**TOWNSHIP OF SOUTH WHITEHALL
LEHIGH COUNTY, PENNSYLVANIA**

PLANNING COMMISSION

May 19, 2022

A G E N D A

SHEET NUMBER:
C-301

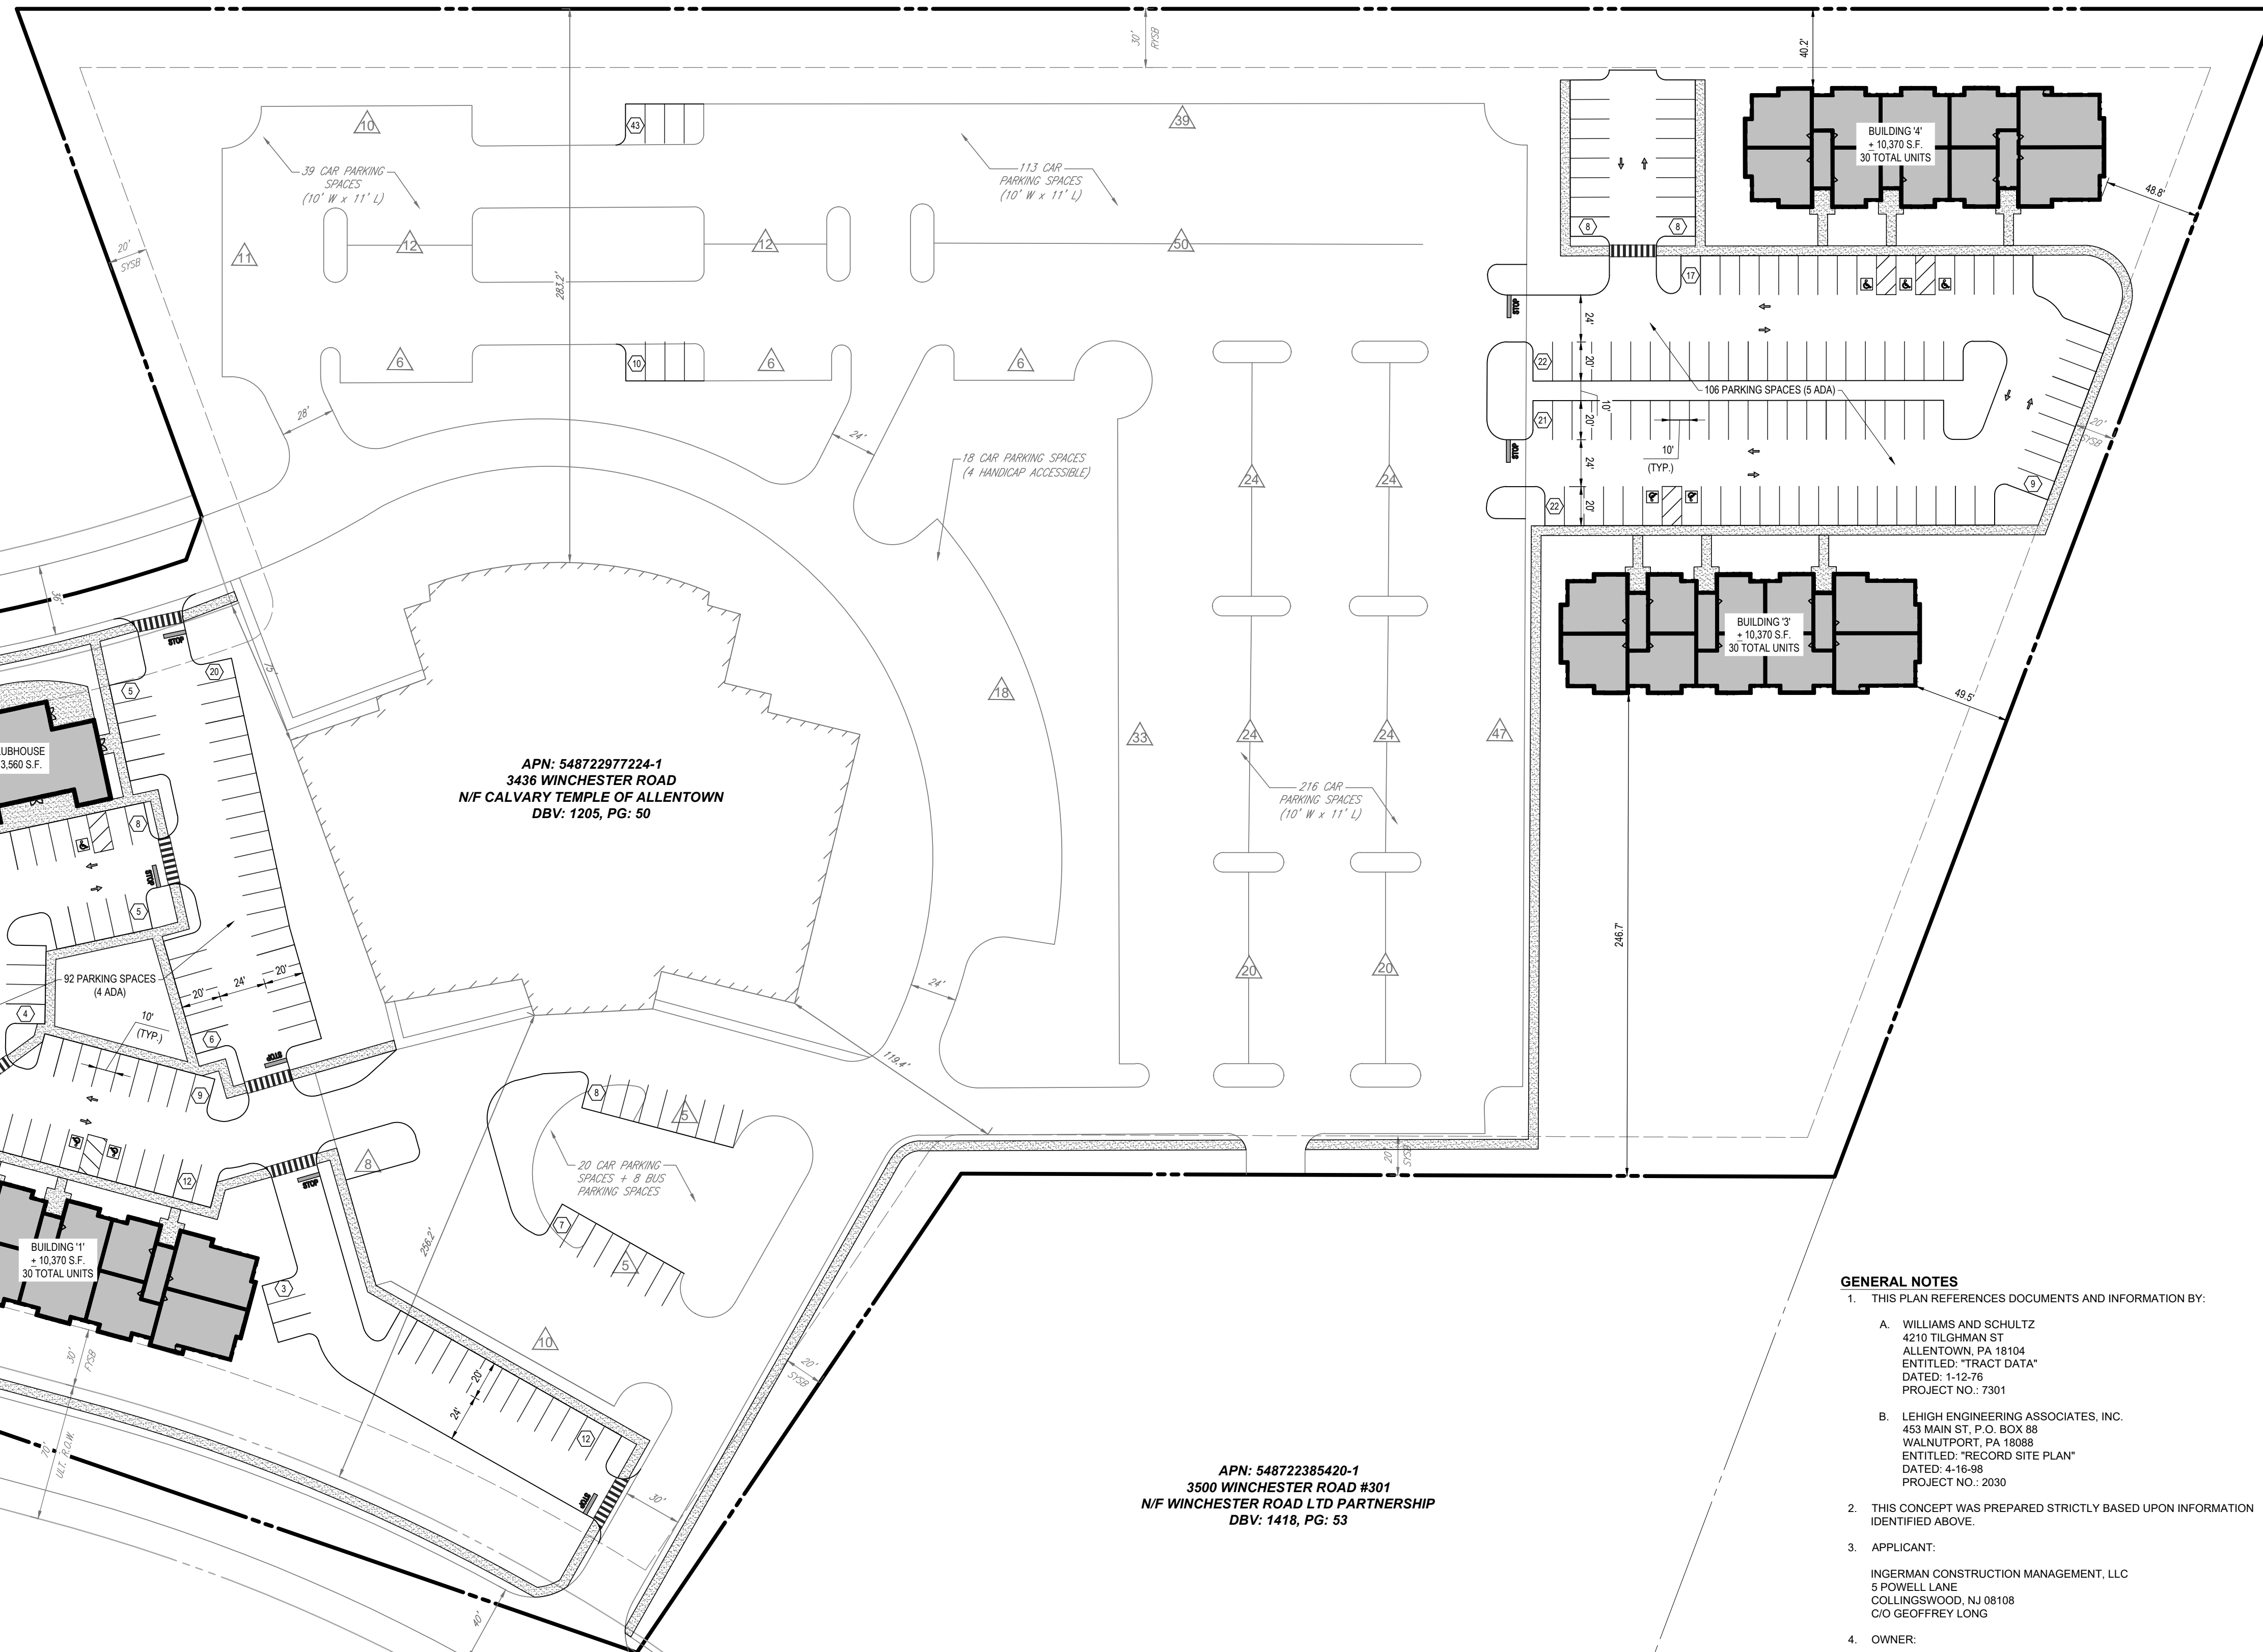
5. Confirm the number of parking spaces to be provided for the place of worship. We note the calculation shows no net change to the existing parking, while the Plans show an increase of 13 spaces;

8. The location map should label the location of the project, SALDO §312-10(b)(6);
9. Show the GC-1 Zoning District boundary along Winchester Road and the R-4 Zoning District Boundary along the western lot line;

OVERALL RECORD PLAN

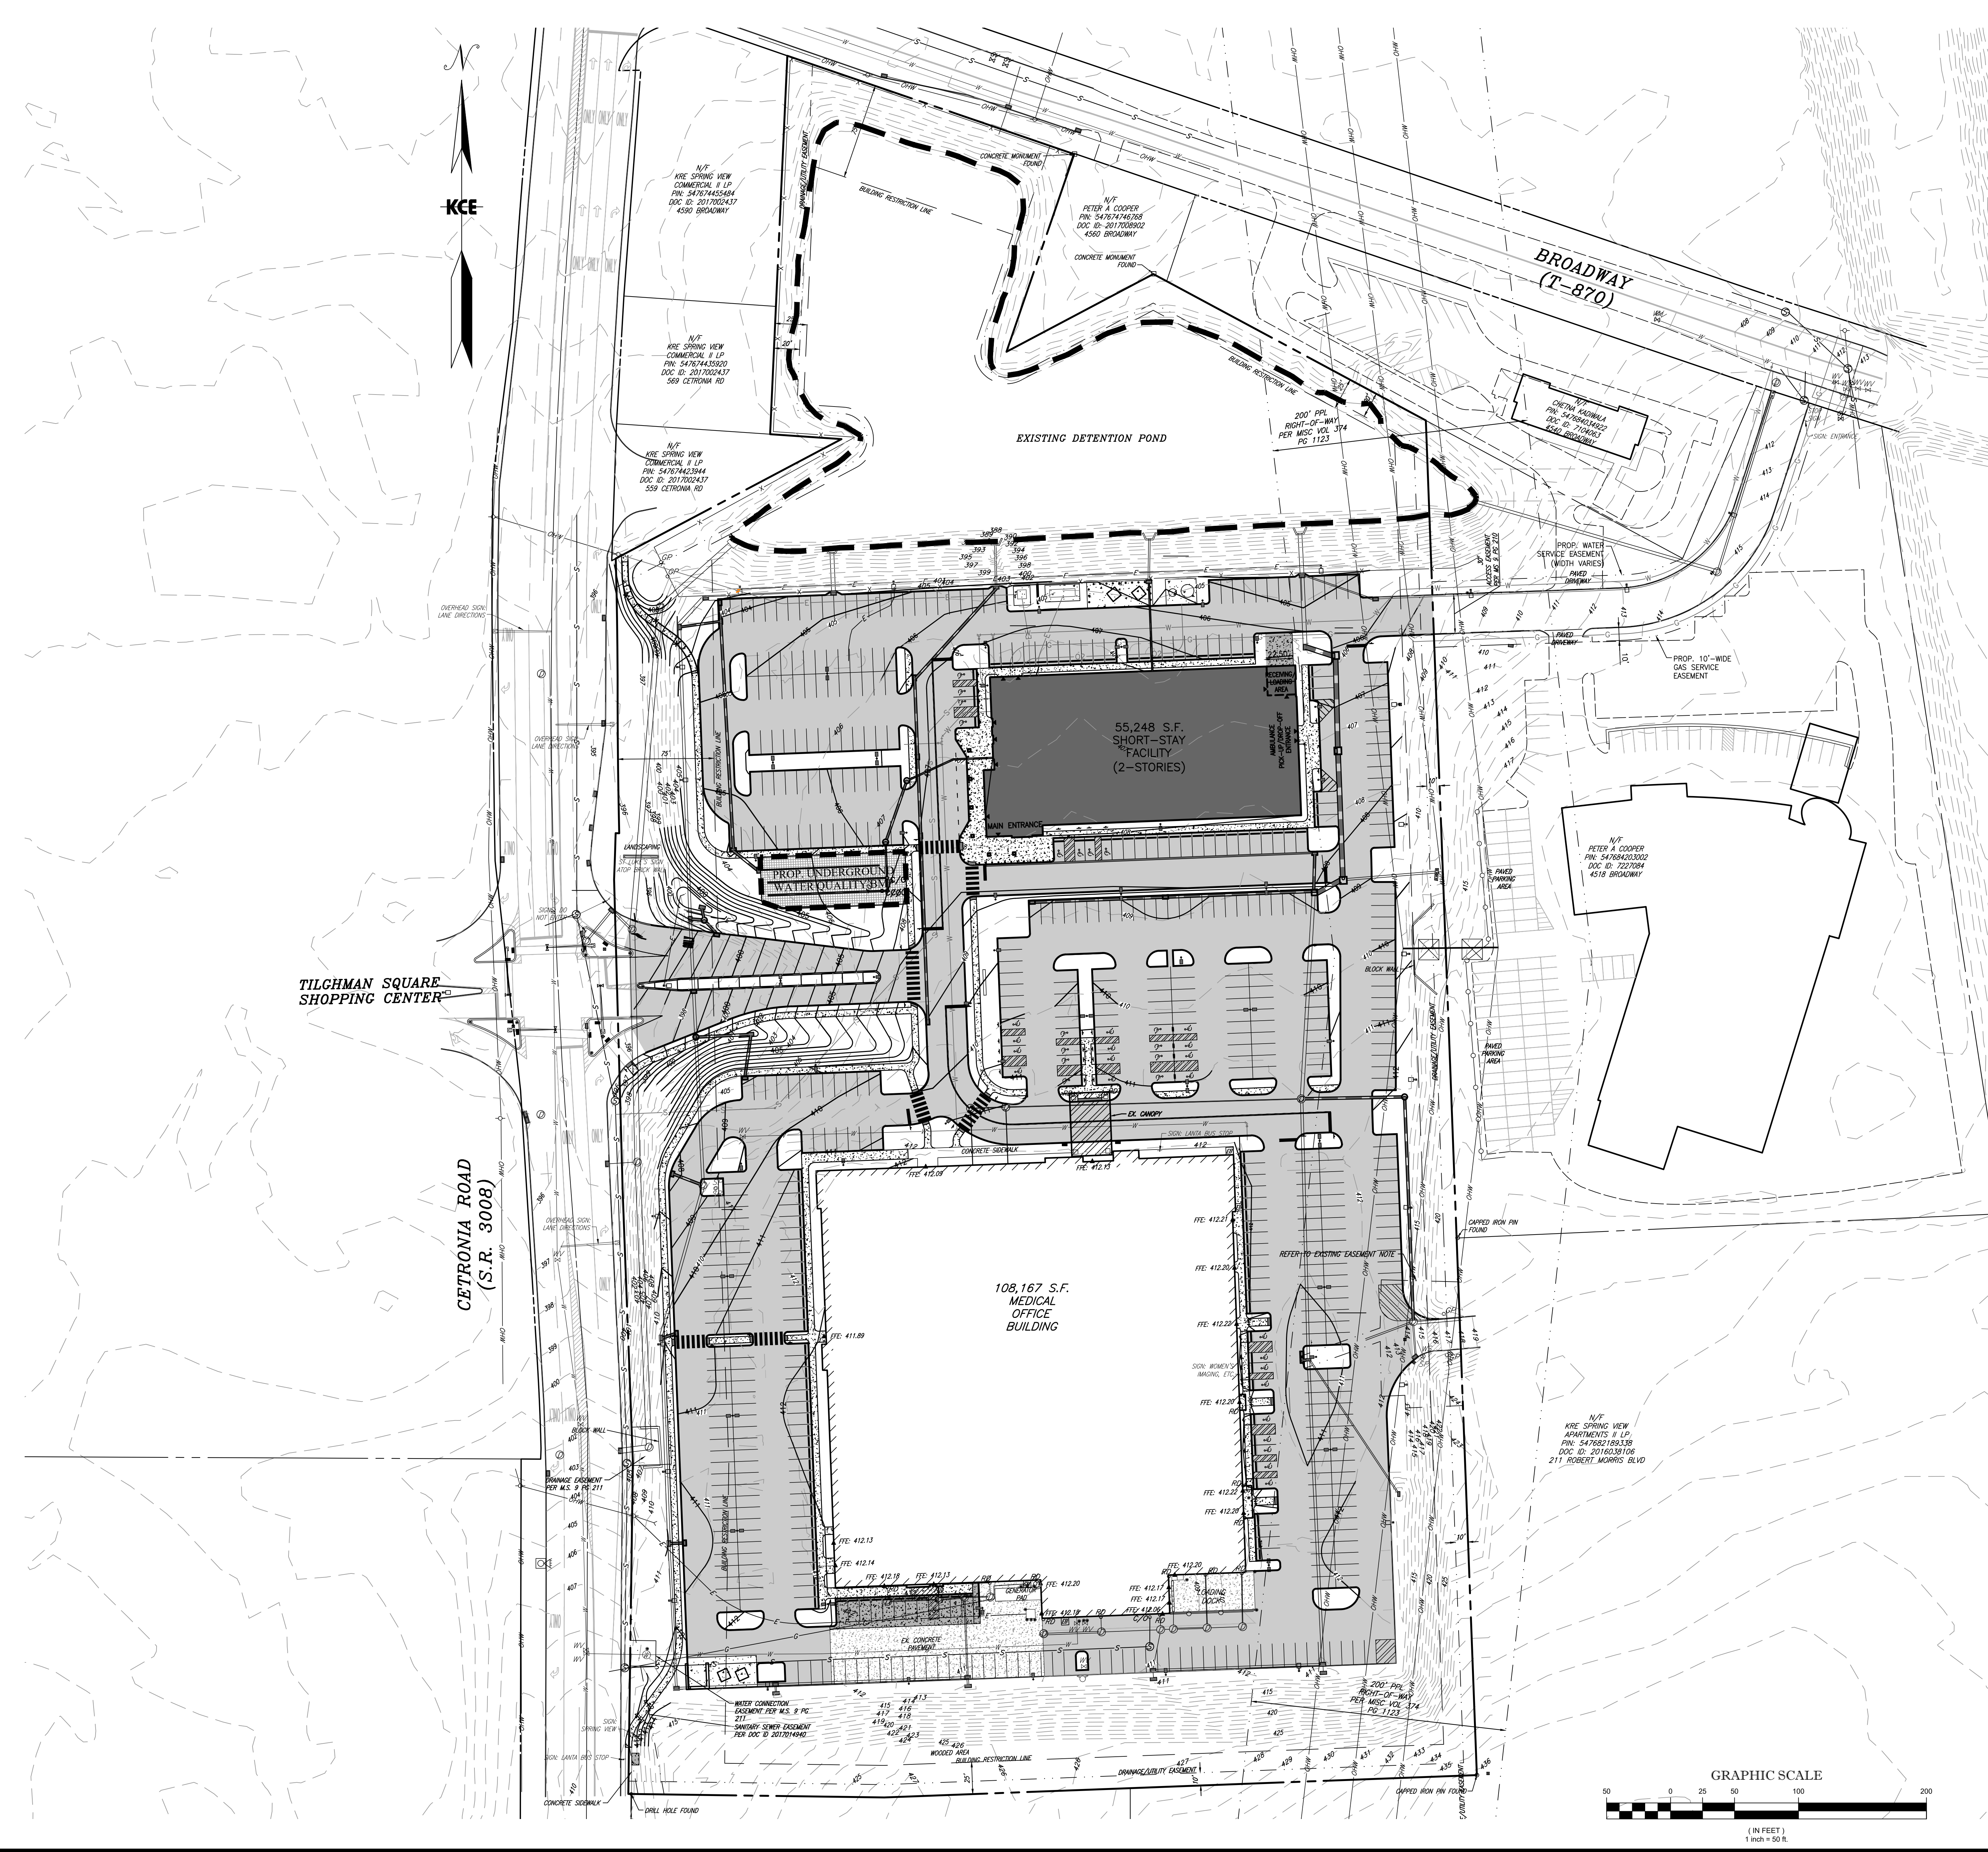
5. Provide a signature line for the owner to sign and seal the Stormwater BMP Operations and Maintenance Note (Sheet 2), SMP §296-29. Also provide the BMP Note on the PCSM Plans, SMP §296-29.

6. Survey Note 7 on Sheet 2 indicates that the Survey and Plans were prepared without the benefit of a Title Report and are therefore subject to any easements or other pertinent facts which such might disclose. The Township Solicitor should review the acceptability of this proposal;
